PENNSYLVANIA ELECTRIC COMPANY
THREE MILE ISLAND NUCLEAR STATION UNIT 1

Operating License No. DPR-50
Docket No. 50-289
Technical Specification Change Request No. 84

Technical Specification Change Request No. 84

PEAK SYSTEM PRESSURE FOLLOWING
AFEEED WATER LINE BREAK VS.
MODERATOR COEFFICIENT

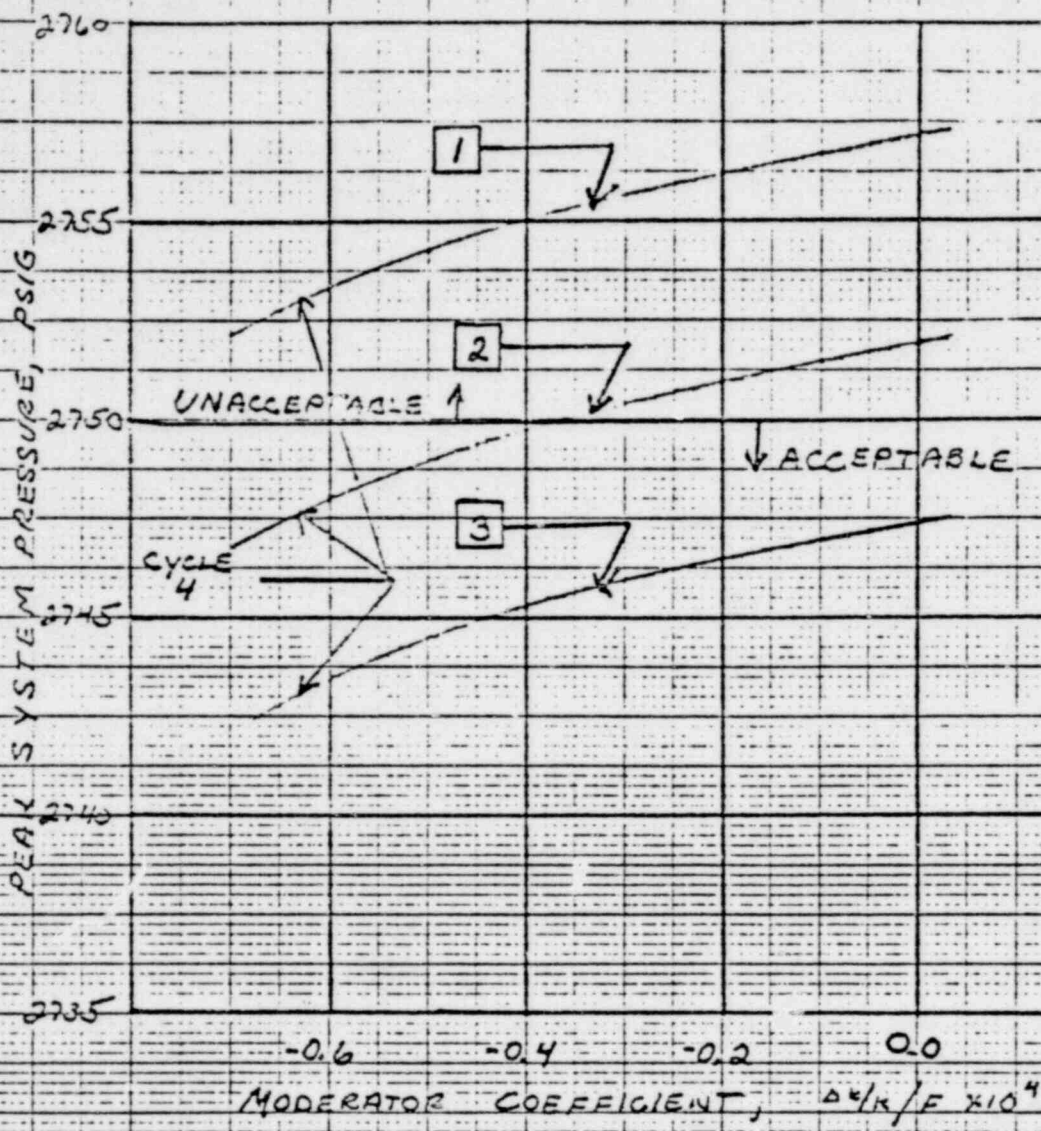
The results in the attached figure show that unacceptable peak system pressures result with the use of the 2405 psig trip setpoint for Cycle 4 and subsequent cycles. This conclusion supercedes that submitted to the NRC April 20, 1978, GCL 0743, where too great a safety valve relief flowrate was used.

To produce acceptable peak system pressures following a feedwater line break for Cycle 4, it will be necessary to lower the high RC pressure trip setpoint to 2395 psig, keeping the safety valve setpoint at 2500 psig. This change will result in acceptable peak pressures for a reasonable range of moderator reactivity coefficients. The attached figure (curve 3) indicates that the peak system pressure is less than 2750 psig for moderator coefficients more negative than $-0.35 \times 10^{-4} \Delta K/K/F$. This acceptable range includes the present Cycle 4 moderator coefficient of $-0.63 \times 10^{-4} \Delta K/K/F$.

The analysis was performed also for a 2390 psig setpoint for reactor trip. Peak system pressure remains below the 2750 psig limit for all negative moderator coefficients. It can be concluded that a high pressure trip setpoint of 2390 psig would suffice for Cycle 4 and all subsequent cycles since a Tech Spec exists to assure that the moderator coefficient will always be negative.

The results of this analysis indicate that a setpoint of 2395 psig is necessary to give acceptable results for Cycle 4. A setpoint of 2390 psi will produce acceptable results for Cycle 4 and subsequent cycles. The 2390 psig high RC pressure trip setpoint has been incorporated in the TMI-1 cycle 4 refined Tech Specs in order to have a fixed setpoint for subsequent cycles.

Figure 2.1-2

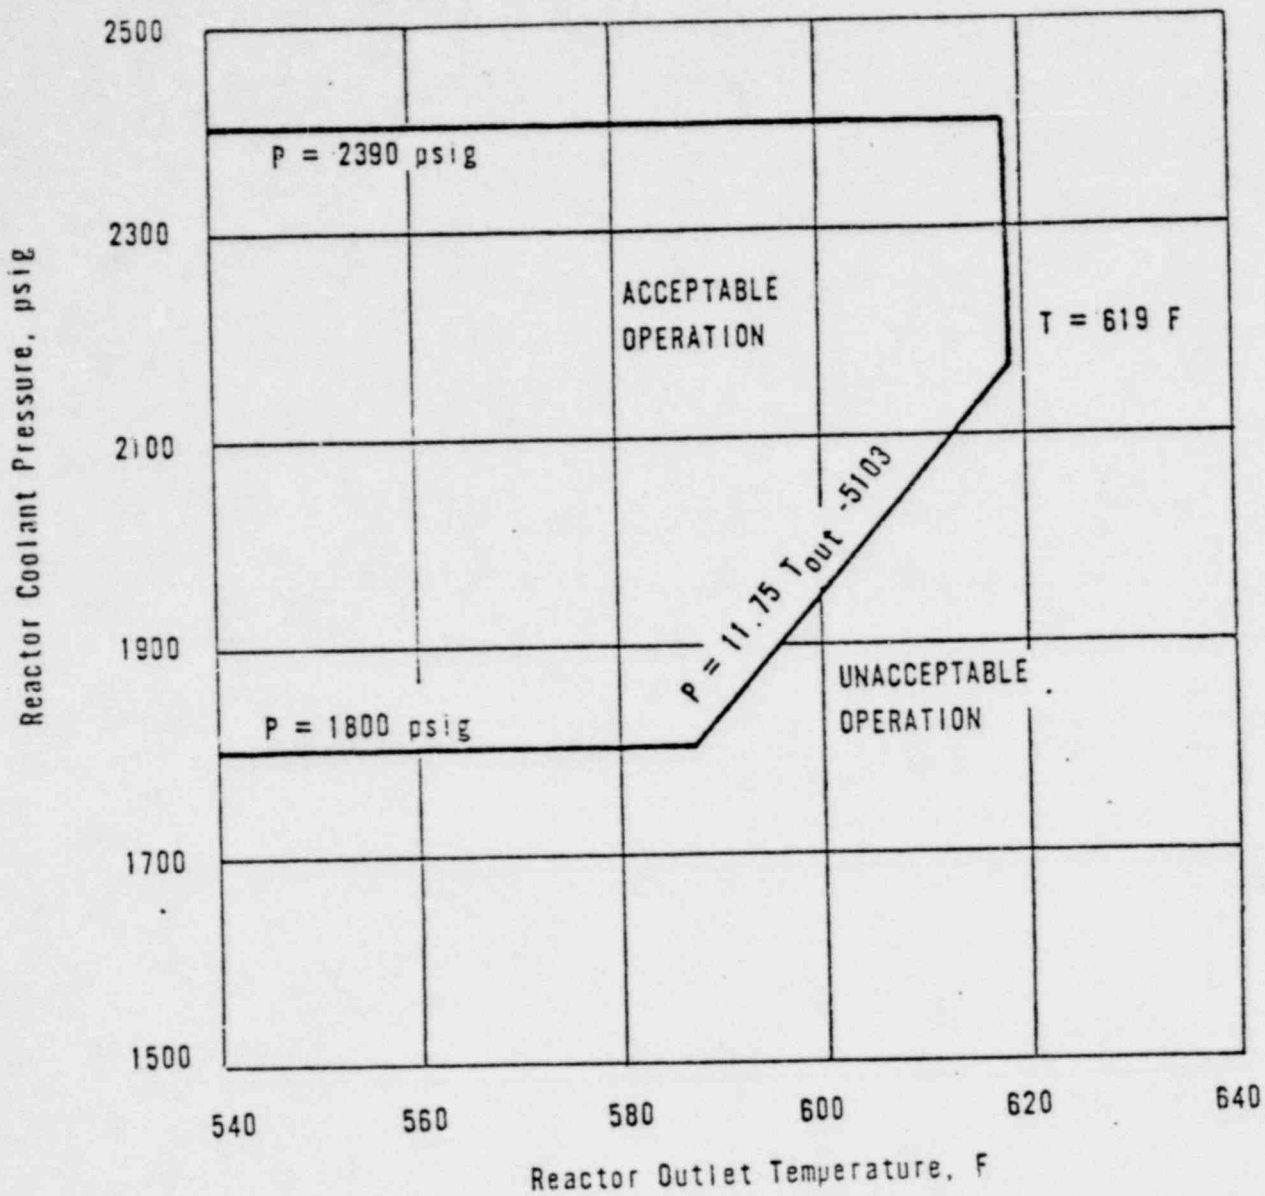
Centerline fuel melt margins and steady-state DNB margins to limiting linear heat rates were reviewed for impact on the Core Protection Safety Limits and Setpoints for Cycle 4. Centerline fuel melt margins versus reactor power imbalance are more restrictive than the current TMI-1 Technical Specifications due to the power distribution anomaly observed in the Cycle 4 Startup Tests, and as a result, the calculational nuclear uncertainty factors were increased to 11% for the radial peak and 13.50% for the total peak. Figure 2.1-2, "Core Protection Safety Limits, TMI-1" indicates a negative imbalance more restrictive than the current negative imbalance safety limits. Further refinement in the analysis to take into account the calculation/measurement adjustment, resulted in changes to Figure 2.3-2. Figure 2.3-2 and Figure 2.1-2, which provides the basis data for Figure 2.3-2, have been refined to account for the extension of Cycle 3 to 287.1 EFPDs and to incorporate the increased uncertainty factors. Both Figures are valid for Cycle 4 (0 to 280 EFPDs).

Figure 2.3-1

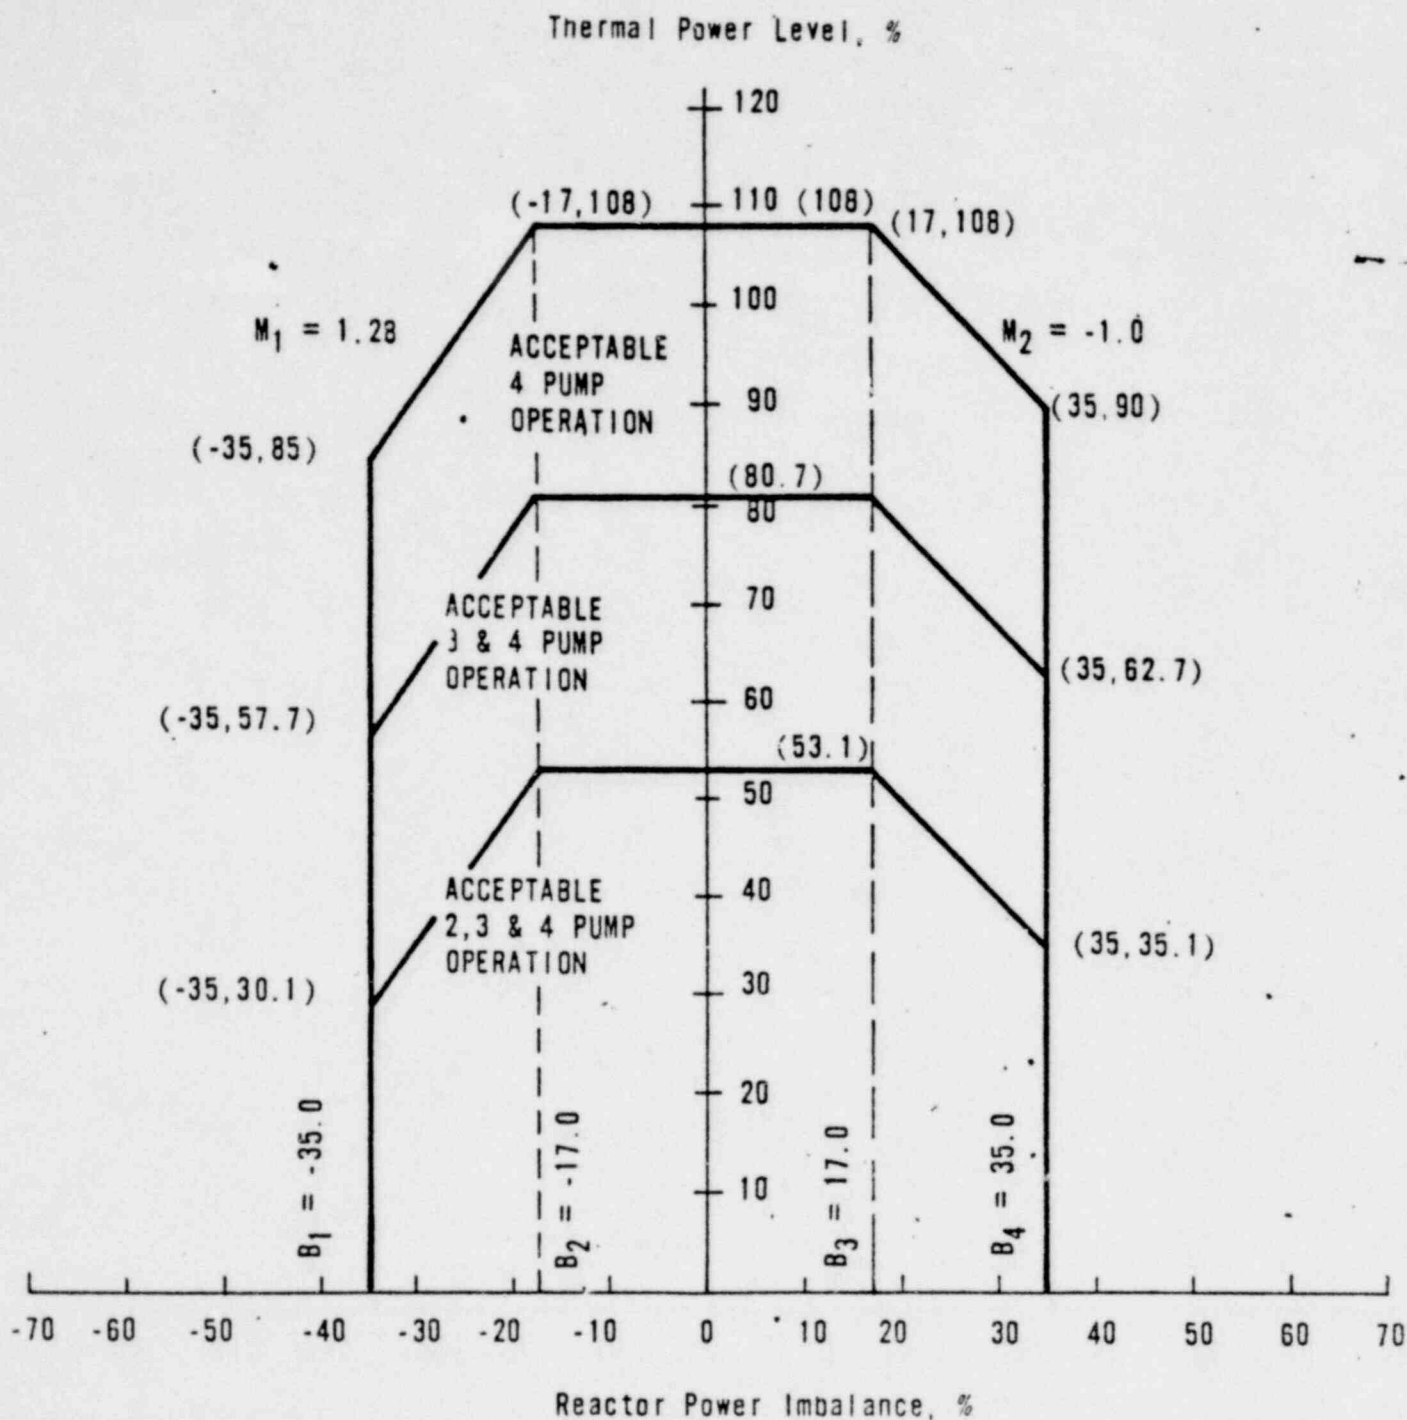
Pages 2-4 and 2-9 and Figure 2.3-1, have been changed to reduce the RC System high pressure trip setpoint to 2390 psig so that in the event of a feedwater line break, the peak RCS pressure will not exceed 2750 psig. Attached to this safety evaluation are the results of the reanalysis which justify the 2390 psig setpoint for Cycle 4 and subsequent cycles. TMI-1 reduced the setpoint to 2390 psig prior to obtaining greater than 40% FP during Cycle 4 startup. This issue does not involve a safety concern and is resolved with this Technical Specification submittal.

TMI-1, Cycle 4
Figure 3.5-2B

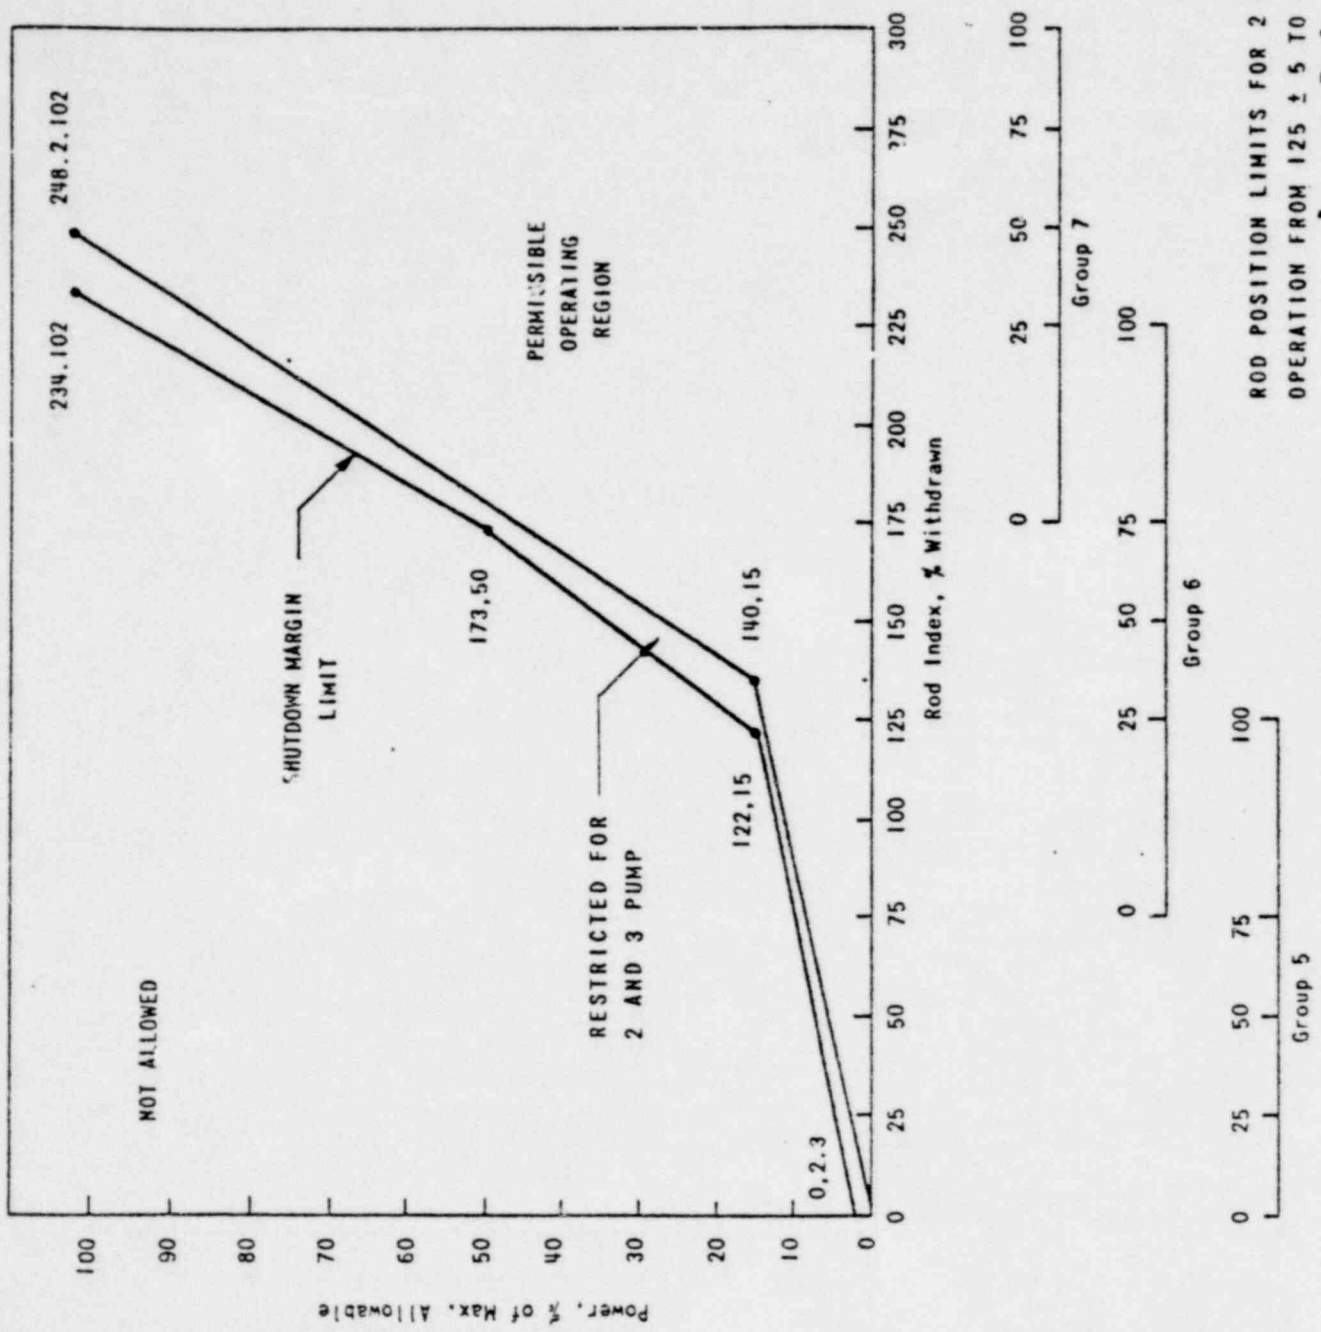
The remaining Cycle 4 period (130 to 280 EFPDs) with respect to rod position limits and the LOCA dependent power imbalance envelope, will be governed by the attached Figures 3.5-2B, 3.5-2D and 3.5-2F. In general, the rod position limits have a slightly more restrictive shutdown margin limit curve and permissible operating region than the figures previously submitted. The high power operating region of Figures 3.5-2B and 3.5-2D has been retained by imposing a more restrictive power imbalance envelope (Figure 3.5-2F), and APSR position limit curve (Figure 3.5-2H, Amendment No. 40, May 19, 1978). Revised calculations indicate that Cycle 4's minimum shutdown margin at 280 EFPDs was 2.19% $\Delta k/k$, well above the 1% $\Delta k/k$ requirements. The maximum ejected rod worth was 0.35% $\Delta k/k$ at Hot Zero Power and 0.25% $\Delta k/k$ at Hot Full Power, well below the limits of 1.0% $\Delta k/k$ and 0.65% $\Delta k/k$, respectively.

Figure 3.5-2D for 2 and 3 pump operation was developed by power scaling the limiting boundary for the "Permissible Region" of Figure 3.5-2B in the recognition of the ordinate of Figure 3.5-2D. The shutdown margin limit of Figure 3.5-2B was not scaled, adding additional conservatism to that limit in Figure 3.5-2D.
